**To:** NHPS Finance and Operations Committee  
**From:** Thomas Smith  
**Re:** Approval of Amendment #3 to Consultant Agreement – SSRCx  
 Helene Grant School Project  
**Meeting Date:** April 19, 2021

**THIRD AMENDMENT TO AGREEMENT  
FOR CONSULTANT SERVICES DATED DECEMBER 18, 2013  
BY AND BETWEEN THE CITY OF NEW HAVEN BOARD OF EDUCATION  
("OWNER") AND SSRcx  
("CONSULTANT")**

**RE: Building Commissioning Services - Contract Amendment  
 Helene Grant  
 New Haven Public Schools  
 New Haven, CT**

**Re: Commissioning Site Visit of September 27-29, 2016 – SSRCx Site Visit Report 11  
NHPS – Helene Grant School  
New Haven, Connecticut  
SSRCx #1344061.0**

**Figure 1: This is referring to item  
0066 - Algae in the basin of the  
tower.**

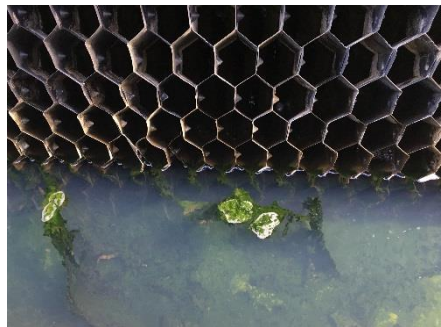
- c. Item 0066: The cooling tower fill has been cleaned but the basin of the cooling tower has algae growing on the fill and in the basin. The biocide program should be reviewed to ensure it is working properly.
